NPP Chinon B Reactor 1 LTO
Environmental Impact
Assessment

Expert Statement

Project Manager Klaus Gufler

Figure 2: French active fault database and location of the Chinon NPP redrawn from: JOMARD et al. (2017); RITZ et al. (2021).

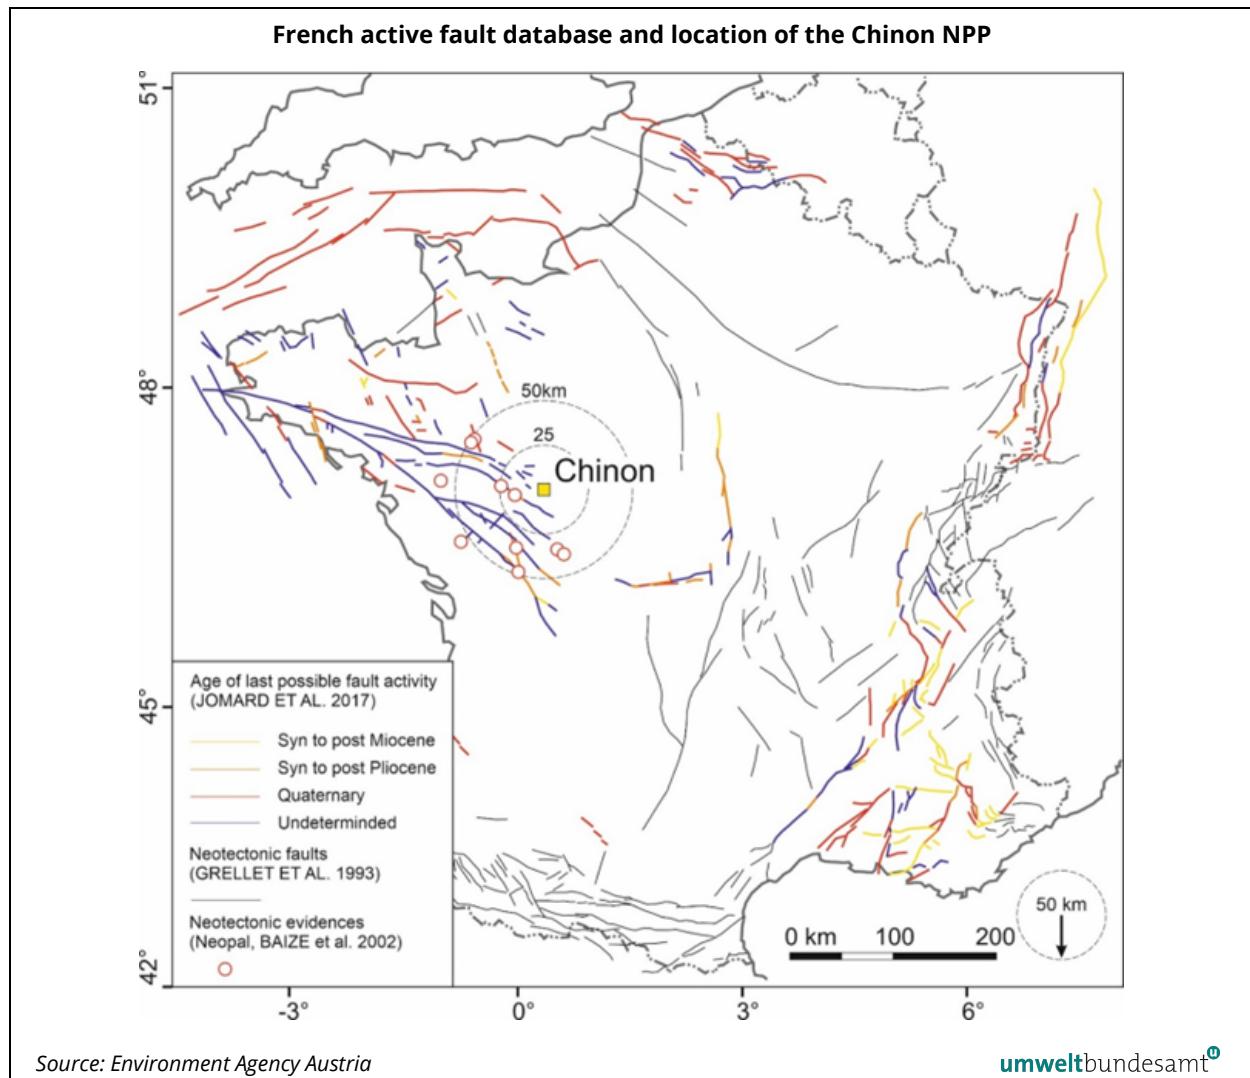
the SND⁷ (EIA-REPORT P.2 2025, p. 166). By definition of the SND, this value corresponds to an average earthquake return period of 20,000 years. No PSHA results other than the single value characterizing the SND are communicated. Documents, in particular, do not show hazard curves and do not state a ground motion value characterizing the 10,000 years earthquake (occurrence probability of 10^{-4} per year) which, according to WENRA (2021), shall be used to define the seismic design basis of existing NPPs⁸. It is therefore unclear if the deterministically derived seismic design basis value for Chinon B, the SMS with 0,2 g, can be defended against a PSHA-derived design basis earthquake with an average recurrence interval of 10,000 years. The relatively high value for the SND (0,34 g) suggests that this may be not the case.

The EIA documents do not provide information on the methods, data and assumptions of the PSHA other than claiming that “*seismic studies [are] compliant with international best practices (Type 1 study)*”. The notion of type 1 study remains unexplained. With respect to methods and data it is worth noting that state-of-the art PSHA is based on both, earthquake and active fault data. EIA-REPORT P.2 (2025, p. 126) claims that no active faults exist in the area within 25 km from the site. This information is taken from the active fault database by JOMARD et al. (2017). Based on this evidence, EDF concluded that further investigation of faults is not necessary.

Figure 3: Schematic diagram of the mobile cooling circuit of the fuel element pool (PTR bis) (EIA-REPORT P.2 2025)

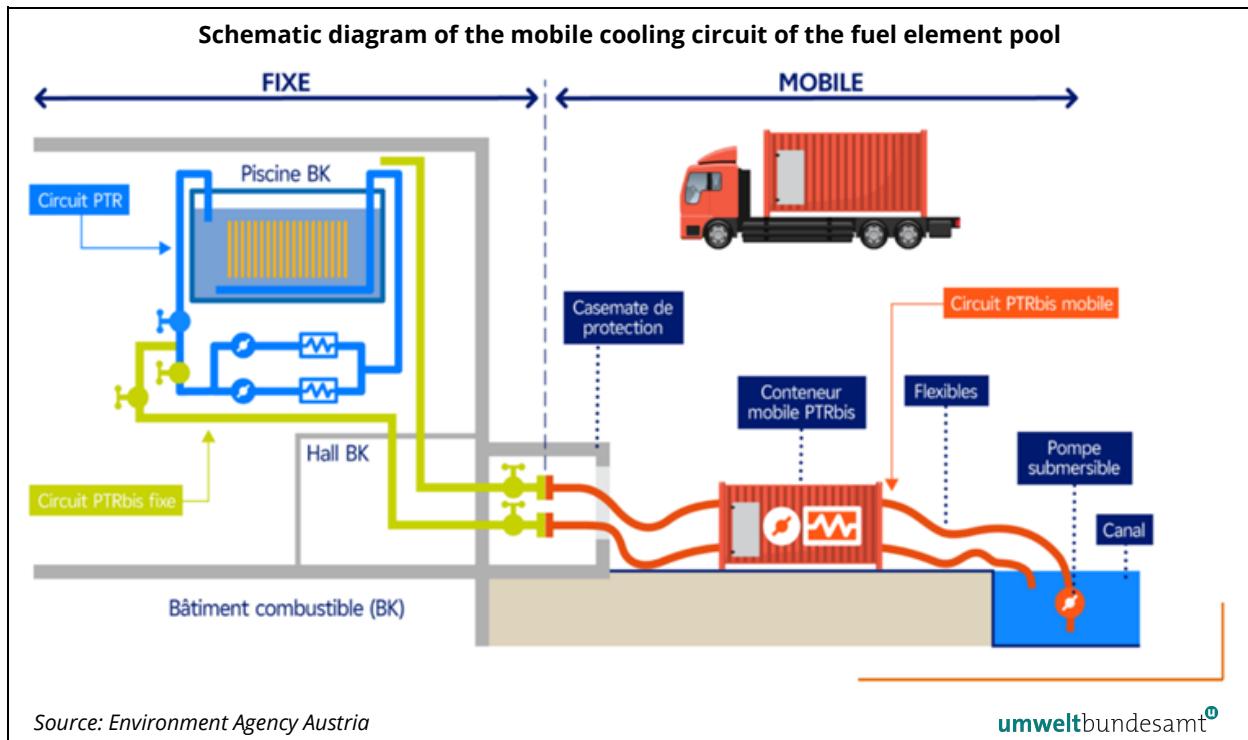
While the mobile cooling system is already implemented, the fire prevention system is still in the planning phase.
